PCN-20230621 TEF0007-02A to TEF0007-03 Hardware Revision Change

Company	Trenz Electronic GmbH
PCN Number	PCN-20230621
Title	TEF0007-02A to TEF0007-03 Hardware Revision Change
Subject	Hardware Revision Change
Issue Date	2023-06-27

This change affects all Trenz Electronic TEF0007 SoMs: TEF0007-02A*.

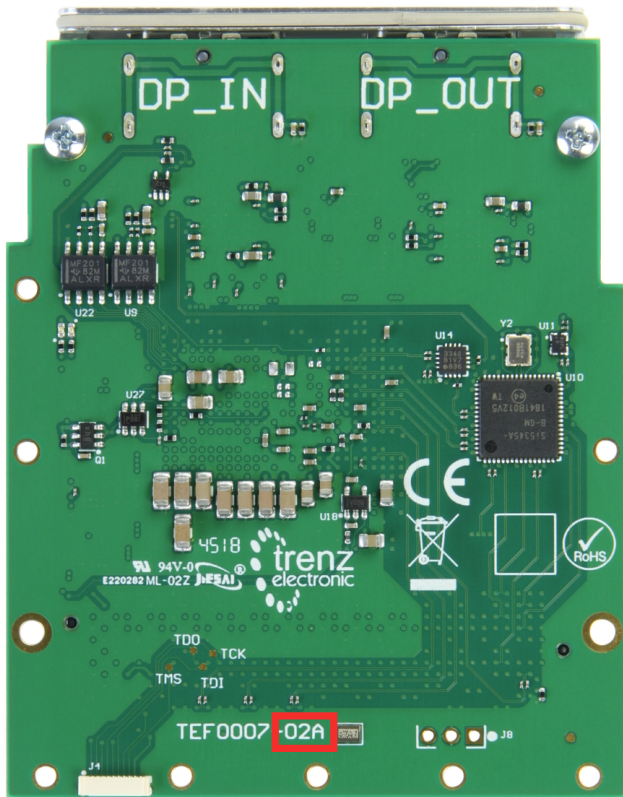
#20 Added legal notices, revision history, system and power overview. Removed clock overview. Updated page count and order.
